PM9A1 FW Change Notification

2022. Aug

Memory Business, Quality Assurance Division

[Fig 1]

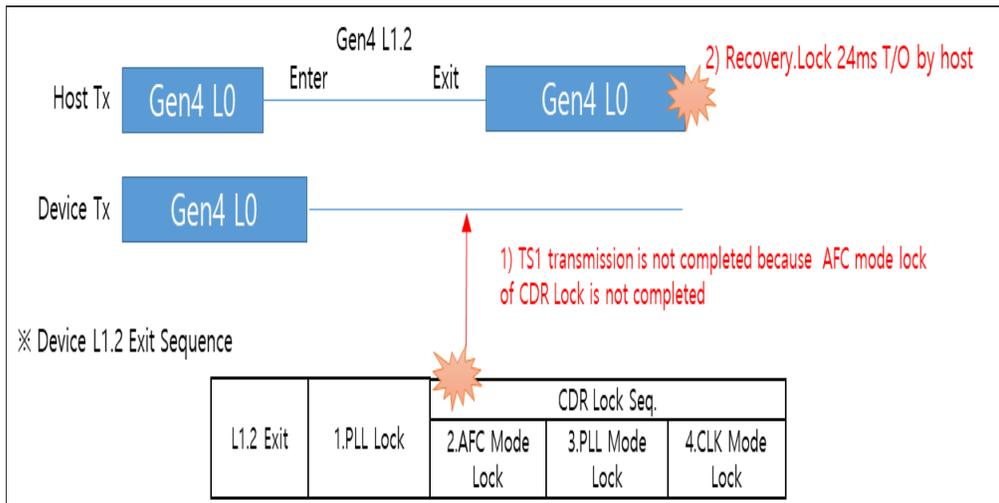
- Found Recovery.Lock 24ms Timeout when exit L1.2 during Modern standby testing

- Device couldn't send TS1 (training Sequence 1) to Host and finally Recovery.Lock 24ms Timeout occurred and Link down happened
- When exit L1.2, CDR (Clock and Data Recovery) Lock of CTRL is not properly completed [Fig 1]
- The slow completion of VCM(Reference voltage of VCO in AFC circuit) settling was observed with very low probability during the AFC Sequence
- VCO(Clock oscillation circuit) malfunctioned due to the slow completion of VCM settling at fail samples

[Fig 2]

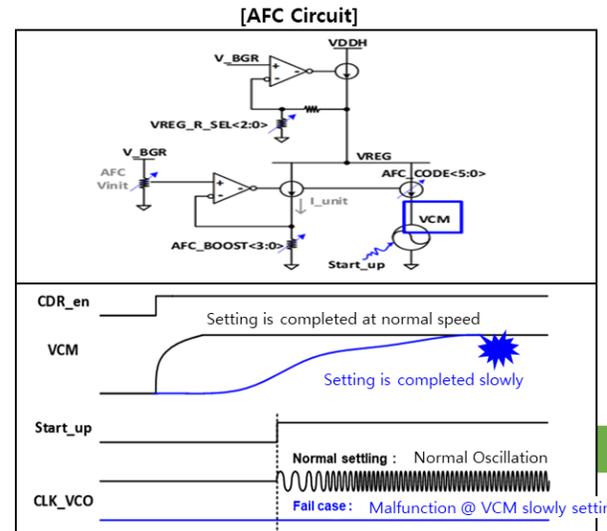
[Fail Mechanism]

- 1) SSD exit L1.2
- 2) VCM settling slowly during AFC @ Fail samples
- 3) VCO oscillator malfunctioned due to VCM settling
- 4) Can not meet target Frequency during AFC

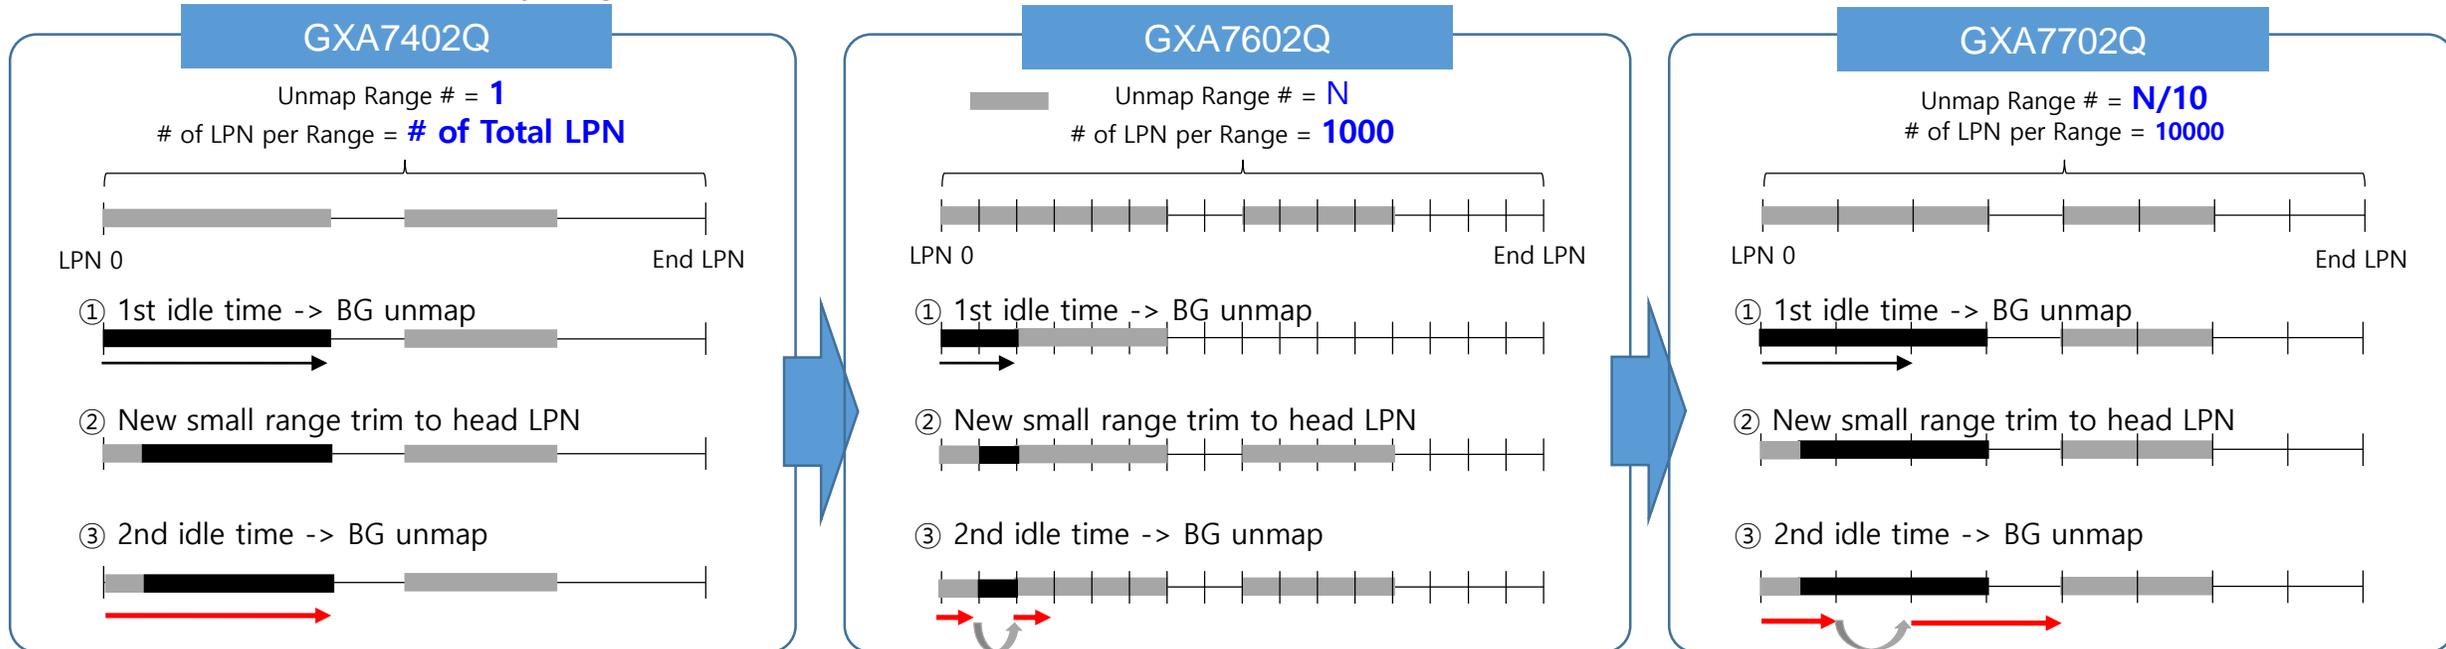
- SW encryption time takes so long

- It is related to side effect from previous Change item(Unmap process optimization)
- Splitting # of LPN per Unmap Range was essential to guarantee to enter PM, but # was excessively small @ GXA7602Q
- FW handling time for Unmap are lengthened → Free Blocks are generated more slowly
→ Ratio of unnecessary Migration & TLC write is increased

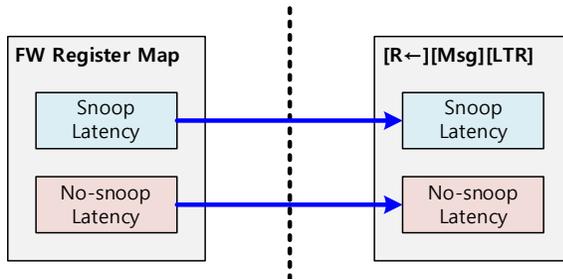
- LTR Latency value Register was reversed

- Register mapping related to Snoop/No-snoop latency of device FW Header was reversed.

- Header file of Device FW is fixed.
